RANCHO SANTIAGO COMMUNITY COLLEGE DISTRICT

ADDENDUM NO. 2

Bid #1506
ORANGE EDUCATION CENTER PORTABLES PHASE II
at
ORANGE EDUCATION CENTER

Project ID #3762, DSA #04-125366

**WAY FINDING
SIGNAGE DETAILS**

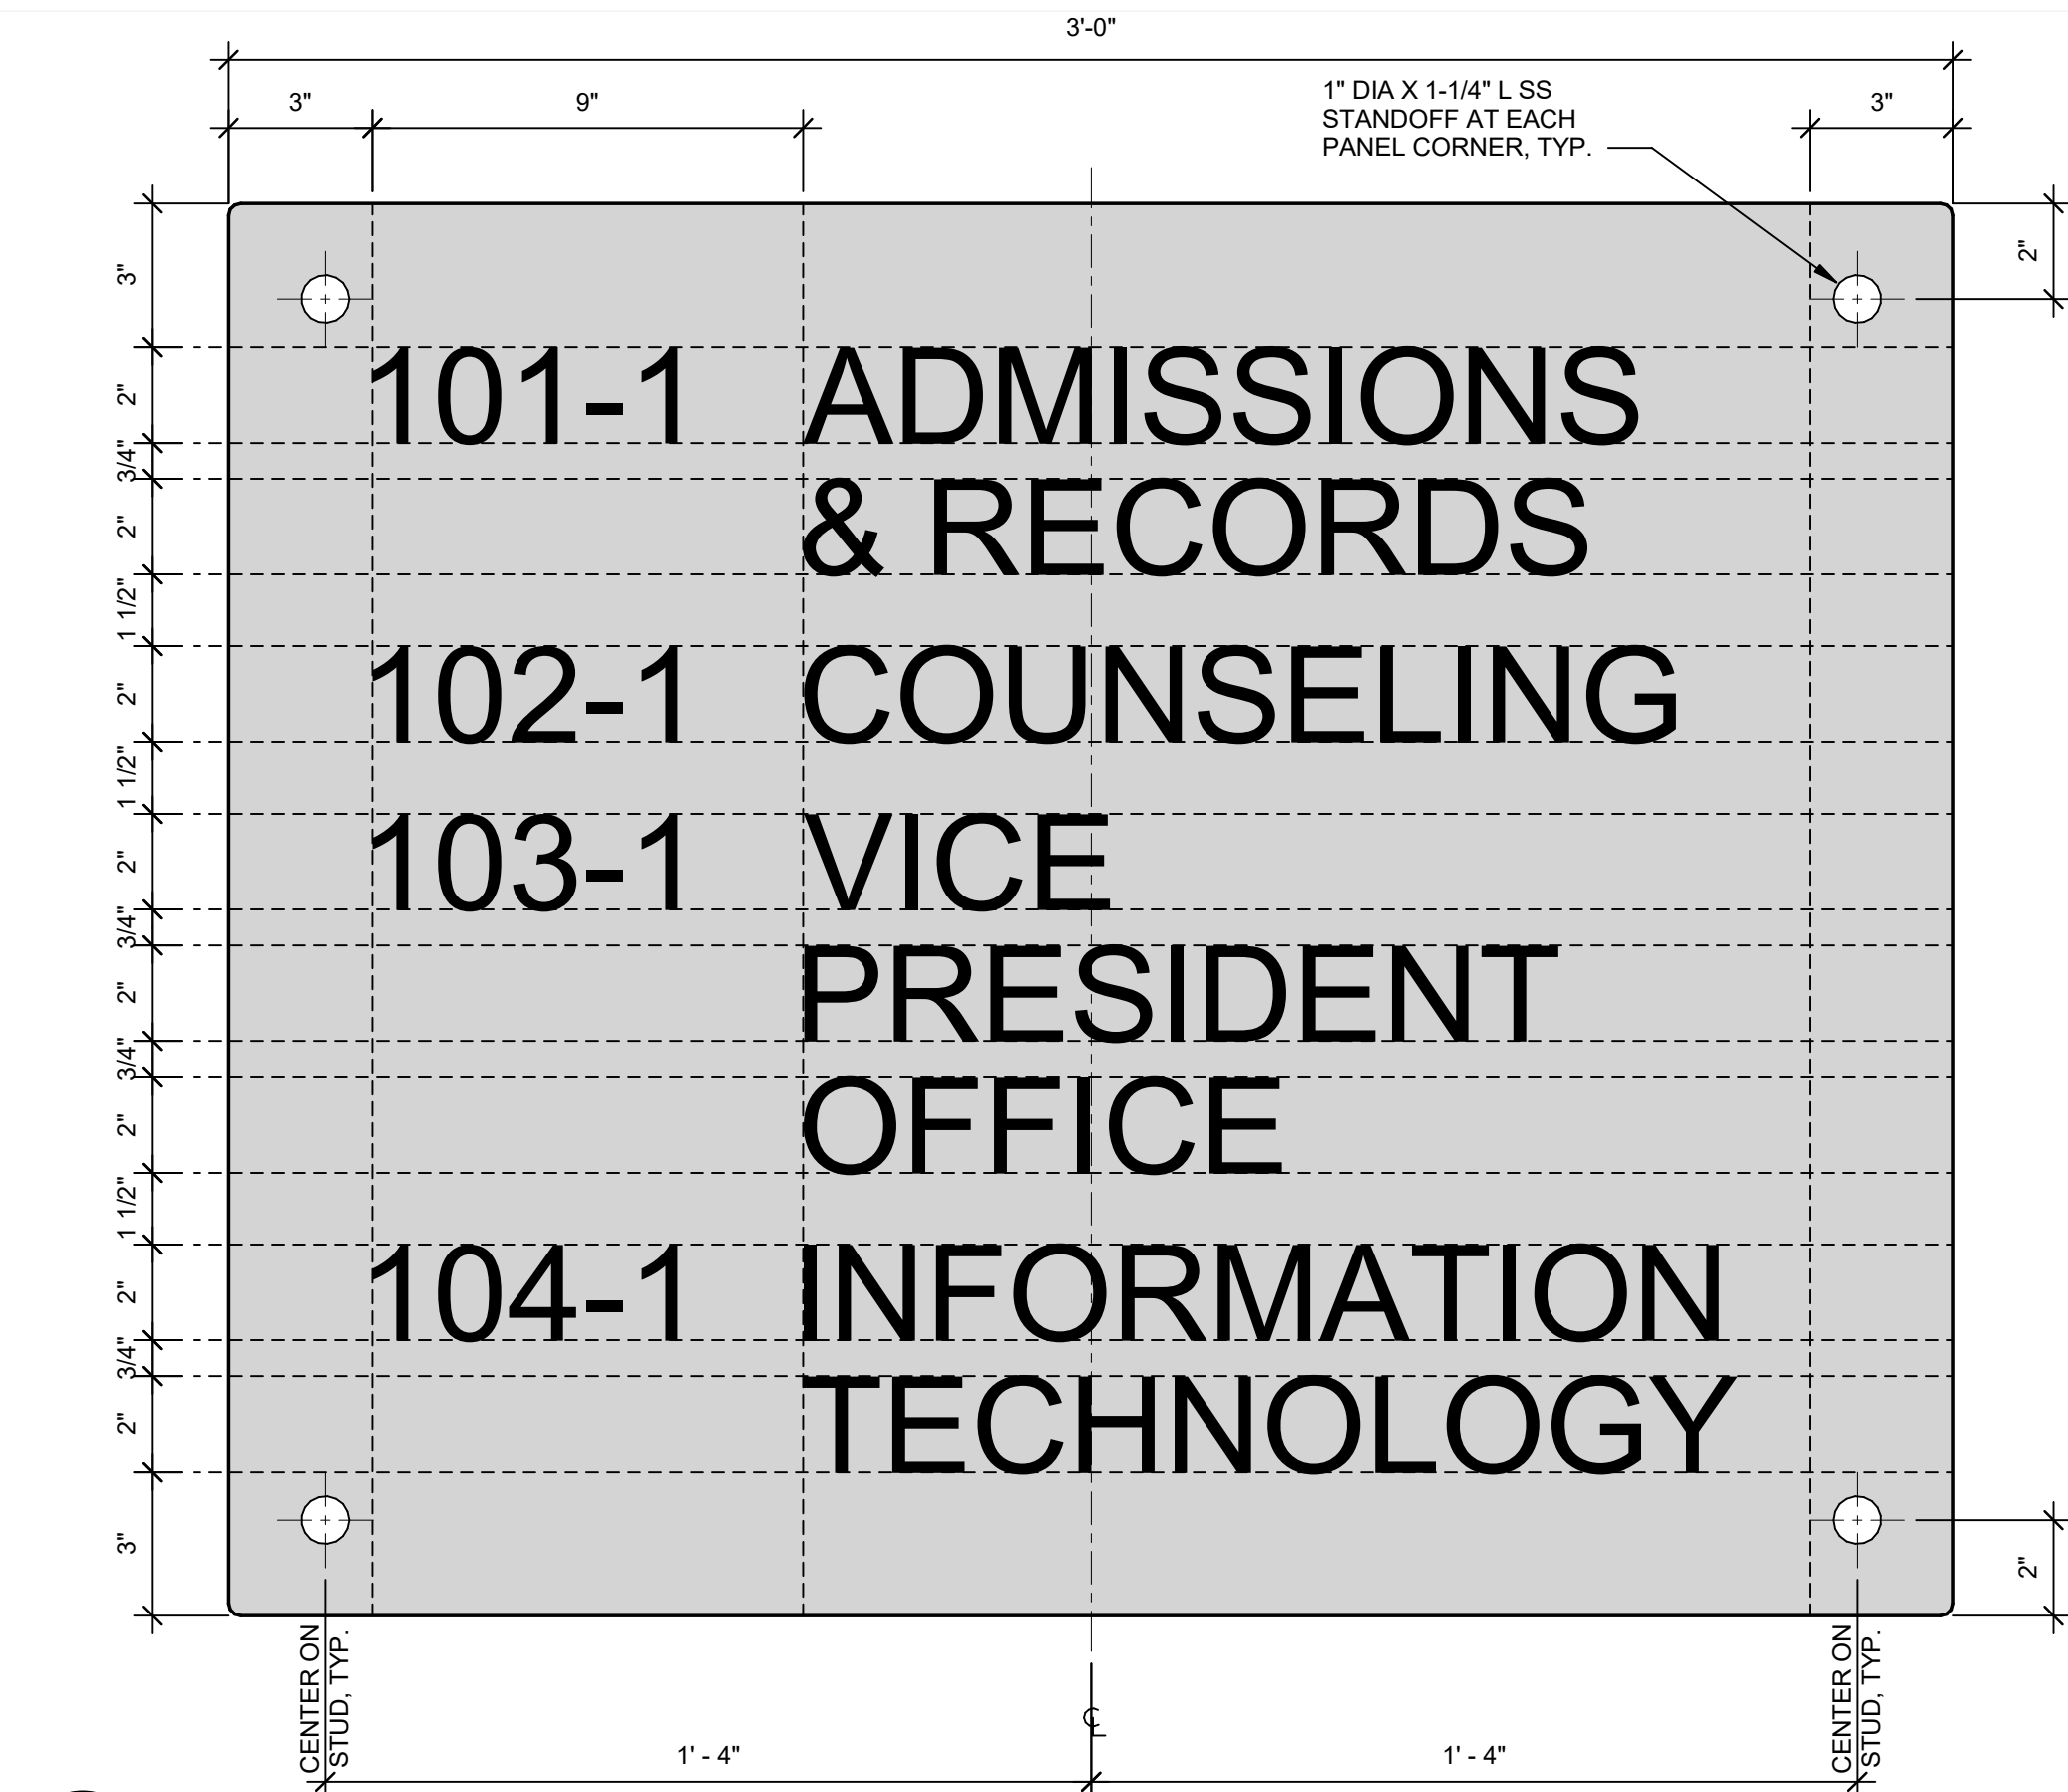
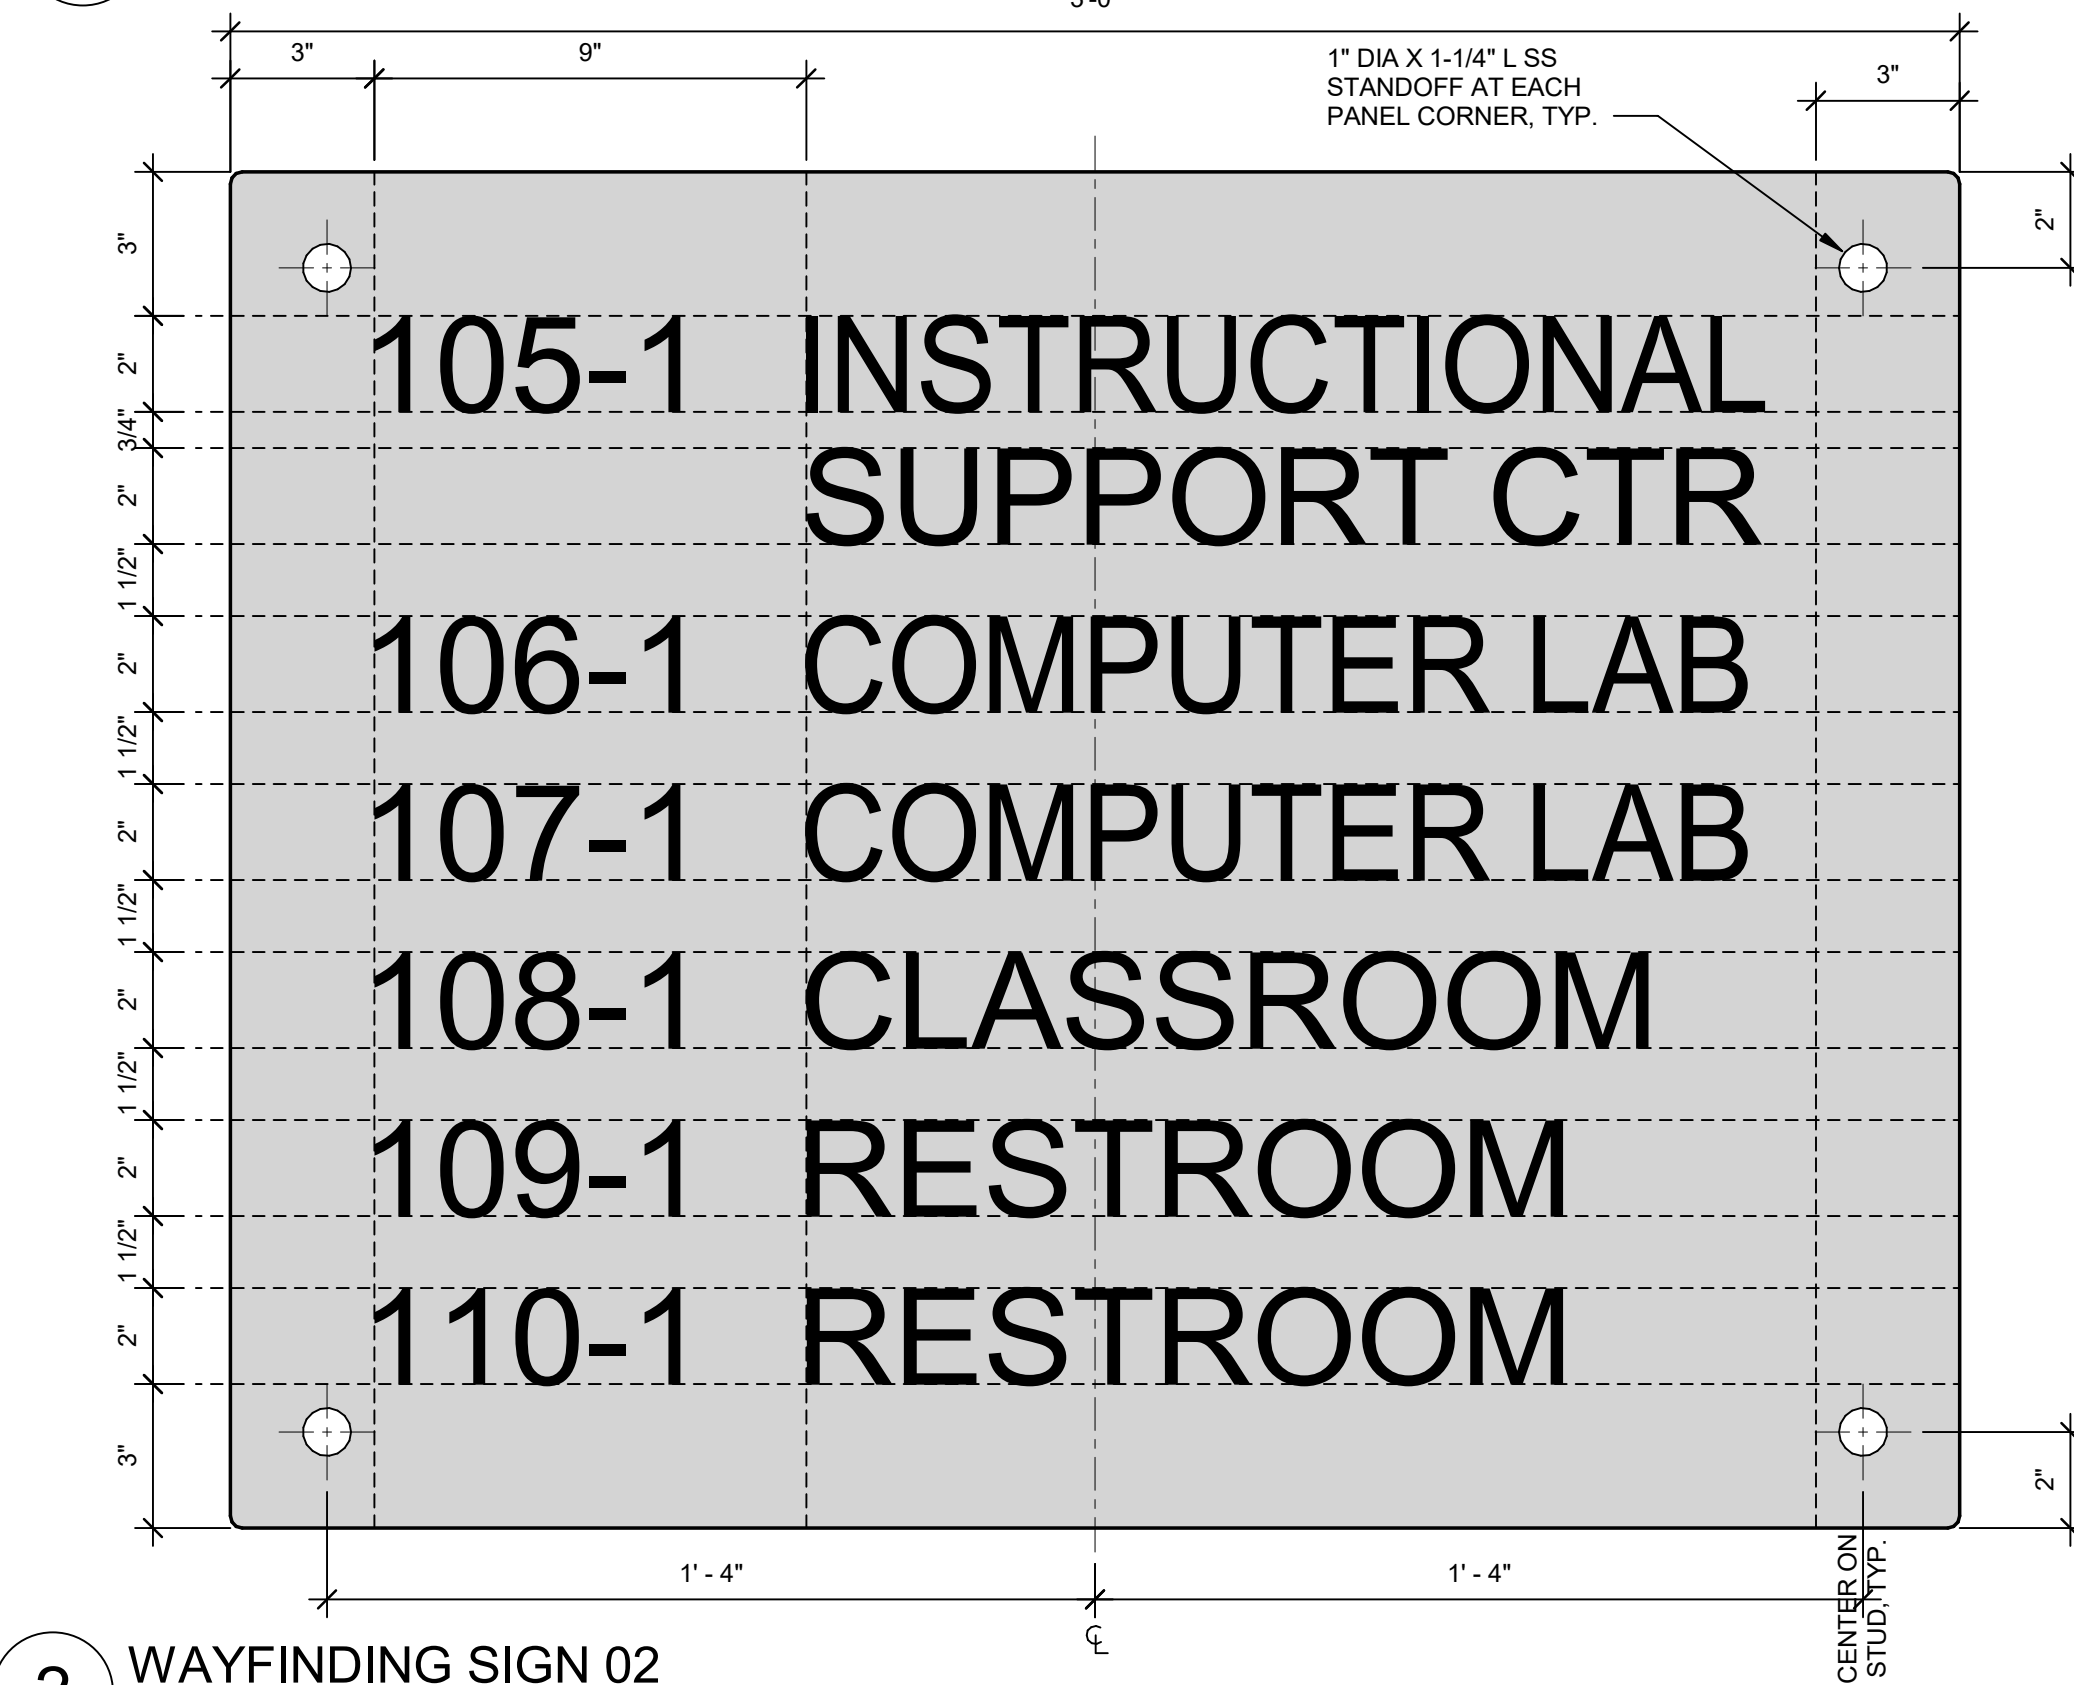
6. A6.02-2, WAY FINDING SIGNAGE DETAILS

Added Addendum Dwg. A6.02-2, Way Finding Signage Details
